CRIME IMPACT STATEMENT

HANSON PLACE, GORRELLS WAY, ROCHDALE
INDUSTRIAL EXTENSION & NEW BUILD (TOTALLING 2,110sqm.)

FOR: Hanson Springs Ltd.

REFERENCE: 2016/0432/CIS/02

1 Visual Audit

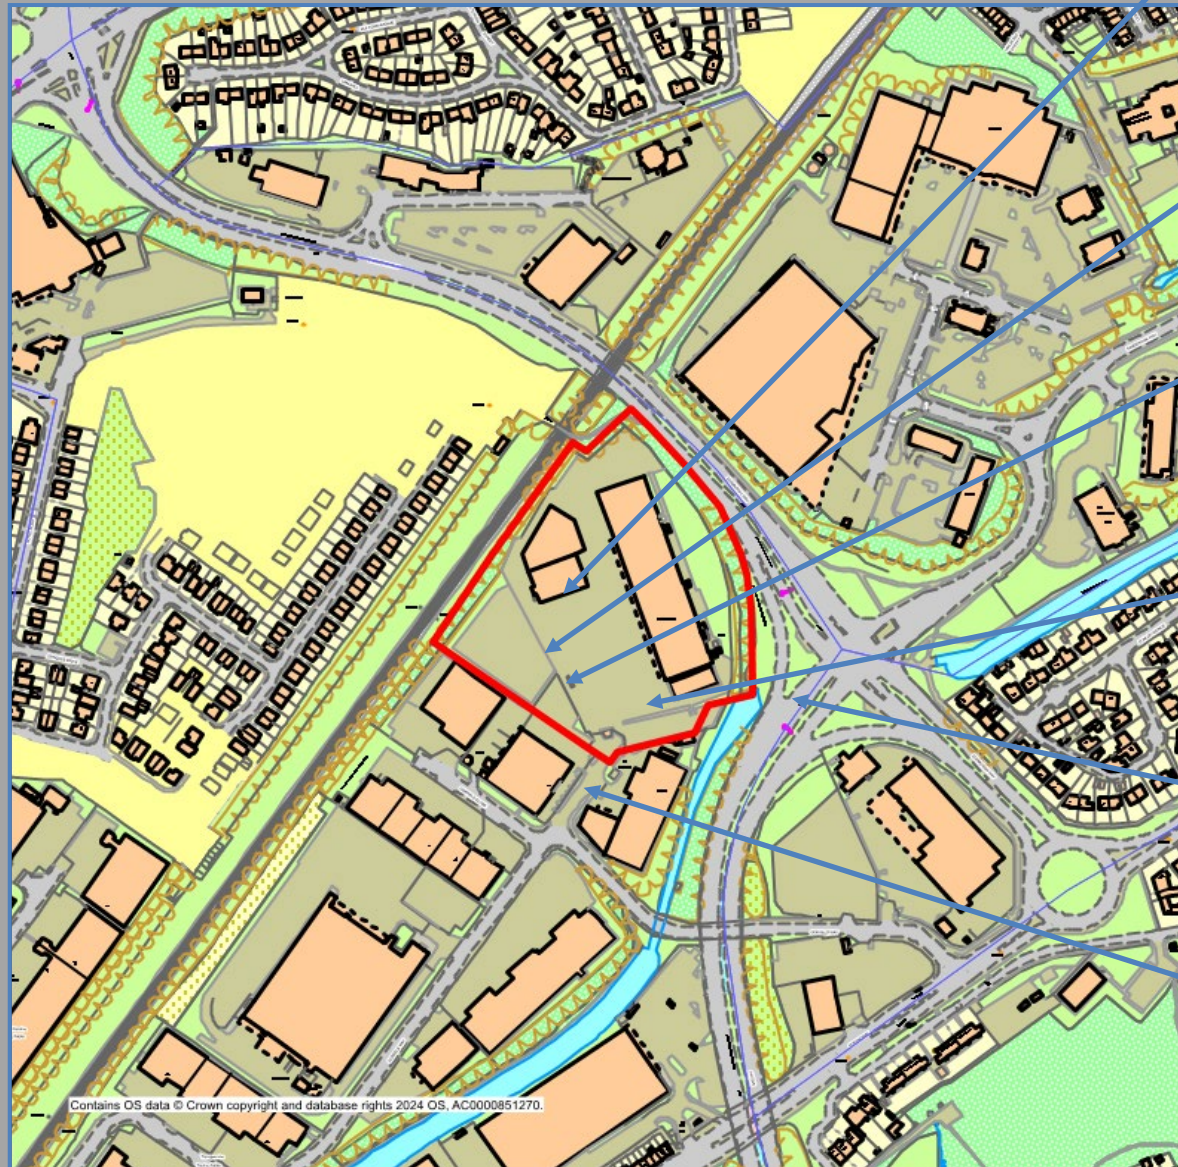
The site is bounded by high walls and Palisade fencing, as well as dense vegetation/mature trees along the adjacent railway line and dual-carriageway. There is a small portion of the site to the south-west that is enclosed with chain link fencing, with secured vehicular gates adjacent to the site entrance.

- 3.3.2 At present, the south-western corner of the site is bounded by chain link fencing, which is not considered an appropriate type of security fencing as it can be easily bent, cut etc. It is highly recommended that the perimeter fencing in this location is replaced with SBD compliant welded-wire mesh fencing or Palisade fencing (see above for more details).

- 3.3.3 The proposed new building (A) will sit close to the perimeter boundary of the site, with a narrow route between its rear elevation and the south-western boundary – obscuring sight lines that currently allow effective monitoring of the area. It is highly recommended that secondary fencelines/gates (approx.. 2100mm high) are incorporated to prevent unauthorised access to the narrow, hidden space to the rear of the new building. If panic mechanisms are required on the inner face of any pedestrian gates for escape purposes, they should not be capable of being reached/operated from the external face of the fencelines/gates. Exposed hinges and large sliding bolt apertures/locking points should be avoided, or fitted with shrouding/protective plates (see opposite) to avoid the creation of footholds. The gap at the bottom of any gates should be small enough to stop anyone crawling through.
